System	Date of Issue	Bulletin Number	Bulletin Type
<b>Odyne Systems G2V2</b>	12/17/15	00029B	<input checked="" type="checkbox"/> <b>Field Service Action</b> <input type="checkbox"/> <b>Technical Service Bulletin</b> <input type="checkbox"/> <b>Technical Service Advisory</b>

**Title: PTO Driveline Repair**

**Issue: Potentially loose PTO Driveline Flange bolt and/or Traction Motor Flange bolt causes vibration which may result in damage to the PTO Driveline.**

**Action: Remove PTO Driveline and install PTO, Motor Flange, and Driveline hardware. If flanges are damaged, request replacements.**

*Bolt, Washer, Flange and Motor*

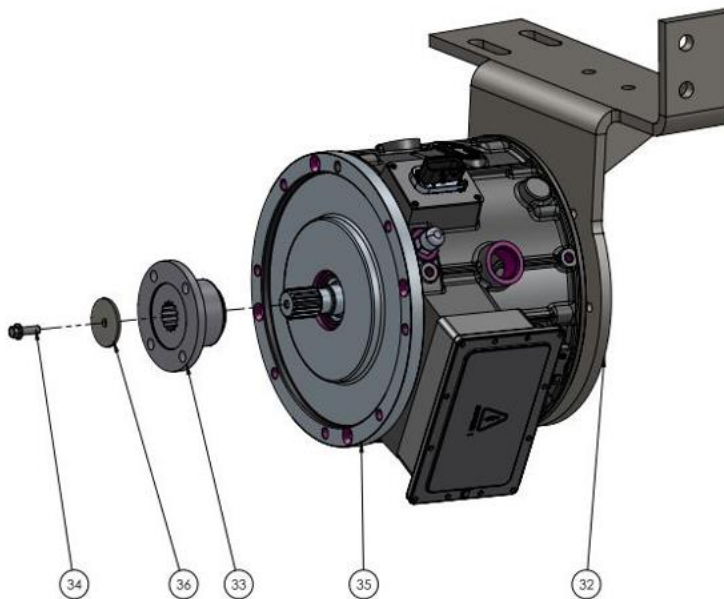
1. Secure the companion flange and remove the M8 bolt and washers from the motor shaft, and discard the bolt and washers.
2. Inspect the companion flange. If it is damaged, remove it and replace with companion flange part number 40074 (ref #33).
3. Install washer part number 30180 (ref #36) on bolt part number 30186 (ref #34).
4. Apply red Loctite to bolt threads.
5. Install bolt into threaded end of motor shaft and torque to 20 Ft.-Lbs.

*Bolt and Washer: Marked*

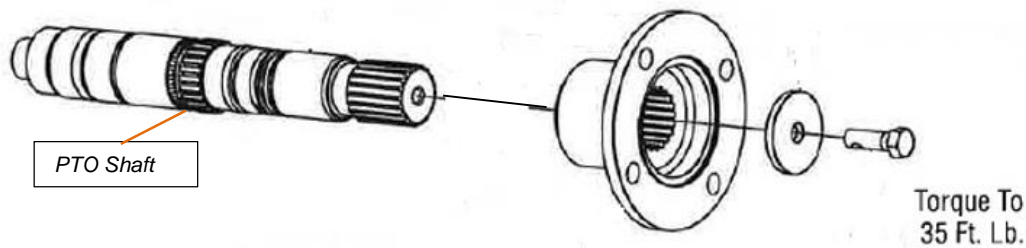
6. Mark the head of the traction motor flange bolt and washer after torqued as shown below.

*Driveline to Companion Flange Bolts: Marked*

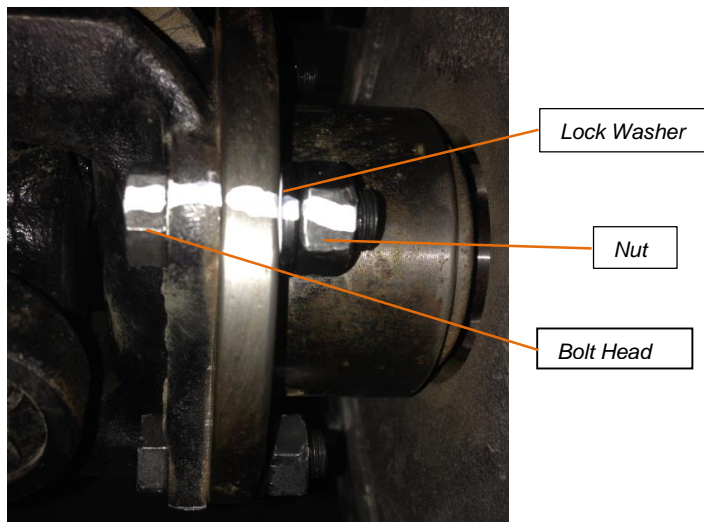
1. Apply red Loctite to the eight new driveline bolts.
2. Install the bolts securing the driveline to the motor flange and the PTO, and torque to 63 Ft-Lbs.

**Installation Tip:** Feed the bolt from the driveline side, and feed the lock washer and nut from the flange side.

3. Mark the head of each of the eight driveline bolts and nuts after torqued, as shown below.
